ADMINISTRATIVE SUBDIVISION PLAN NO. 620220050, BLOCK F KILMAROCK

Administrative Subdivision Plan to create up to two lots for single-family dwelling units; one for the existing dwelling unit and a second for the construction of a new dwelling unit.

No. 620220050

September 22, 2022

Figure 4 – Plan of Subdivision

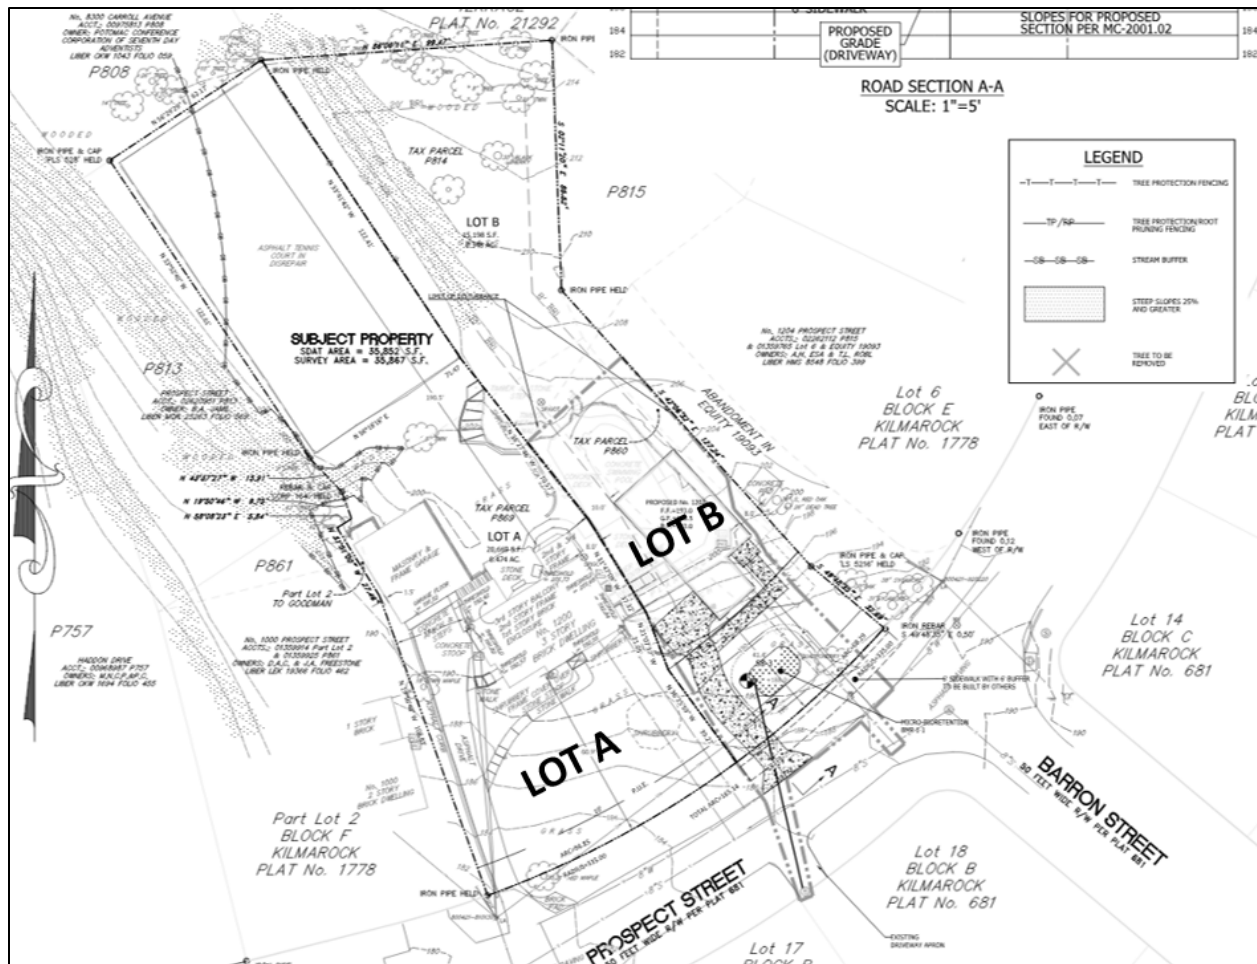
- b) Include the approved Fire and Rescue Access plan in the certified set
 - c) Update plan sheets to show the stream valley buffer and related 25-foot BRL offset from the stream valley buffer on Lot A as well as the 150-foot rear BRL on Lot B, subject to Staff approval.

Access to the proposed lots will be via separate driveways. Lot A will continue to be accessed from an existing driveway on Prospect Street and Lot B will be accessed via a new driveway also located on Prospect Street, approximately 40 feet from the intersection of Prospect Street and Barron Street (Figure 4).

Figure 5- BRL Exhibit: Forest shown in green, steep slopes shown in orange; approximately 3,200 sf of tennis court area to remain outside of proposed BRL.

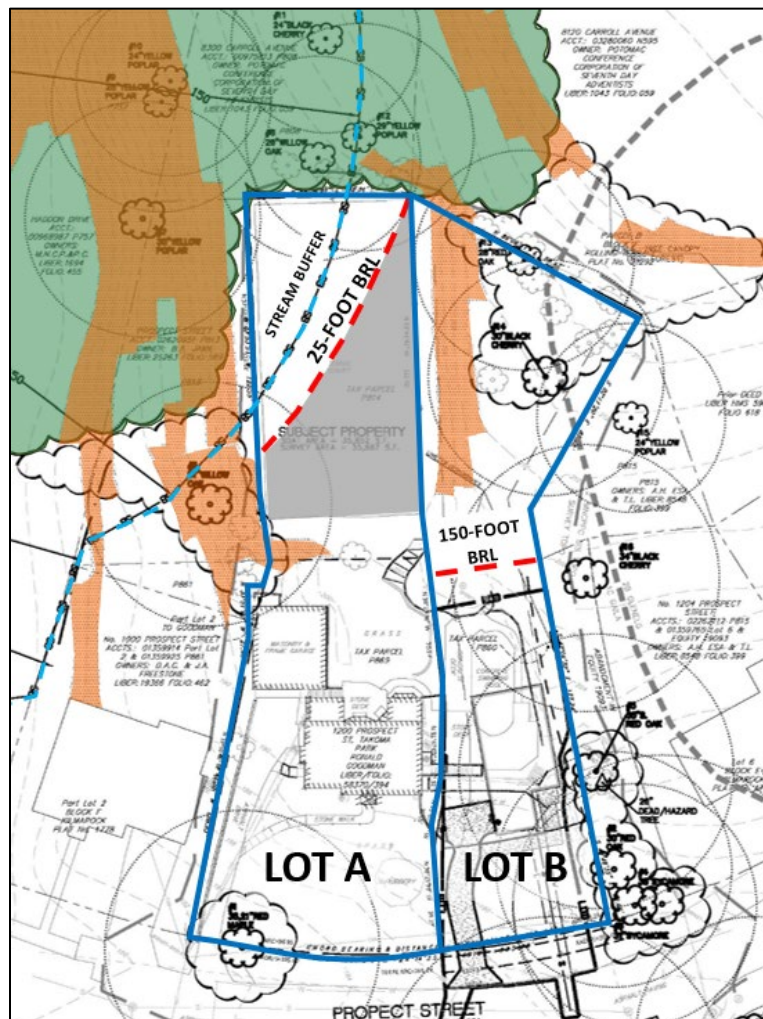
The revised Forest Conservation Exemption application (42023017E), approved by Staff, identifies a stream valley buffer delineated along the northwest corner of Lot A, and then a smaller section of the buffer intersects a portion on the western side of Lot A, just north of the existing masonry garage. The larger section along the northwest corner is prioritized because of its proximity to the stream and the overlapping sensitive environmental features which include areas of forest within the stream buffer as well as steep slopes of at least 25% grade. The smaller section of stream buffer is not prioritized for protection by BRL given its proximity to the existing garage, which will fall within a minimum buffer of 25-feet; this area is also outside of the mapped forest stand and contains only a fringe extent of steep slopes.

The Forest Conservation Exemption also identified steep slopes along the rear (north) portion of Lot B (approximately 150 feet from the rear property line) as well as a grouping of several mature and specimen trees.

To protect the floodplain, stream valley within Lot A , and the steep slopes and mature specimen trees within Lot B, Staff has recommended two building restriction lines; one off-set 25 feet from the stream valley buffer along the northwest corner of Lot A and another, 150 feet from the rear property line on Lot B. Staff has worked within the confines of the Subdivision Regulations and Chapter 22A of the County Code (Forest Conservation- Trees) to ensure protection of these environmentally sensitive areas, while allowing for reasonable future development on the proposed lots.

- a. A 25-foot BRL offset from the stream valley buffer in the northwest corner of the property, as shown on the approved Forest Conservation Exemption (No. 42023017E) for Lot A.
- b. A 150-foot BRL from the rear property line for Lot B.
